**ME-B Hydraulic Power Supply**

Exchange of Spiders

SL2016-617/HDP  
June 2016

Fig. 2: Pump coupling

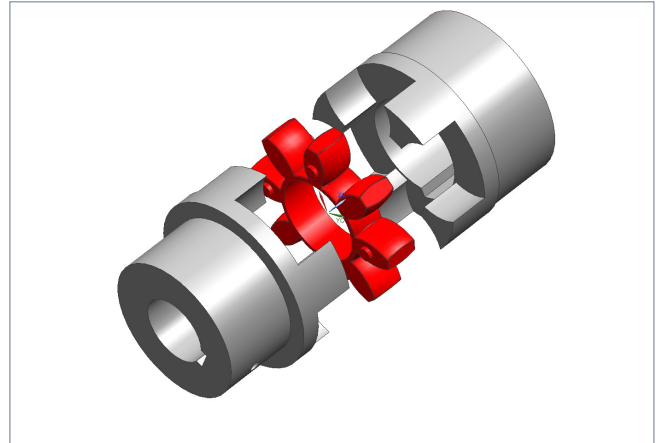
If the existing spider is white or yellow, MAN Diesel & Turbo will dispatch a new set of spiders to replace the old spiders at the first convenient opportunity. Please inform us if wear is observed on the claw parts of the couplings in connection with this upgrade. We will then send out a complete coupling if needed.

- Service Letter SL2016-616/HDP
- IMO No. and engine type
- new spider part no. to be installed: – see Table 2
- delivery address for the parts
- contact person.
